B2B Excellence Ltd (Extension 2)

10 December 2023

2. Observations:

Beam layout plan at +4.8 m level

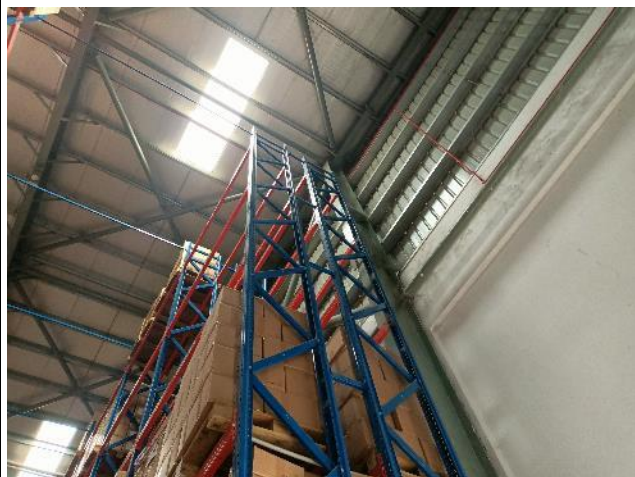
Observation-1: Mismatch in as-built drawing. (Warehouse Building)

No beam at +4.8 m level

Description: At front beam was found missing in first floor level. The building engineer is required to update the as-built drawing correcting the beam layout and submit to RSC.

Items No.	Observation	Action Plan	Timeline
1.	Mismatch in as-built drawing. (Warehouse Building)	The building engineer is required to update as-built drawing with necessary connection details.	within 6 weeks

Vehicle impact risk on column

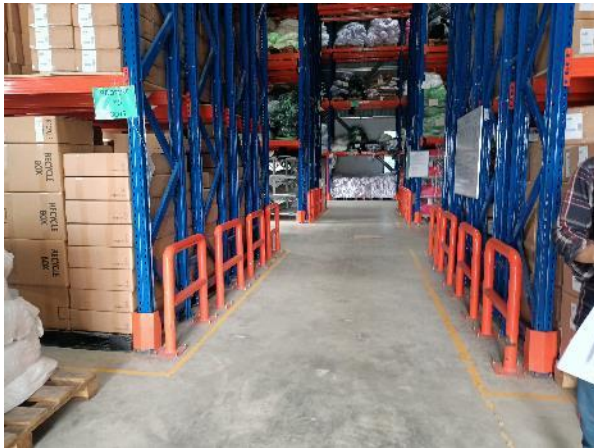
Observation-3: Column susceptible to vehicle/trolley impact. (Warehouse Building)

Trolley impact on column

Description: Columns on loading/unloading and ramp areas are susceptible to vehicle/trolley impact. The building engineer is required to take necessary action to provide barrier around the column to avoid vehicle/trolley impact in the columns.

4.	Column susceptible to vehicle/trolley impact. (Warehouse Building)	The building engineer is required to take necessary action to provide barriers around the column to avoid vehicle/trolley impact in the columns.	within 6 weeks

Idle Machine Shed

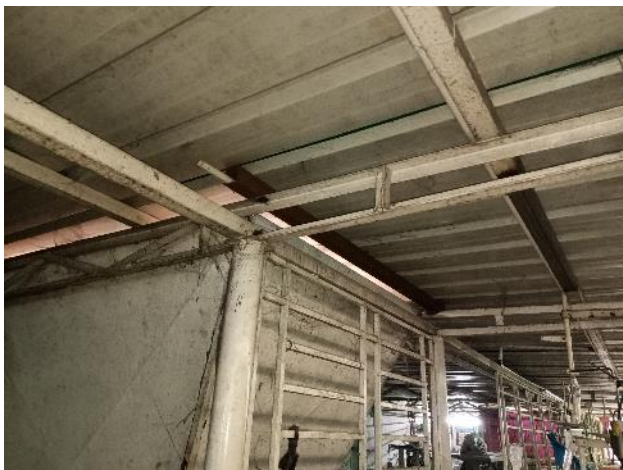
Observation-5: Lack of drawings. (Idle Machine Shed)

Description: Structural and architectural drawings were not found for the Idle Machine Shed. The building engineer is required to survey the structure and prepare a full set of as-built drawings in compliance with BNBC.

7.	Lack of drawings. (Idle Machine Shed)	The building engineer is required to survey the whole structure and prepare a full set of as-built drawings with connection details.	within 6 months
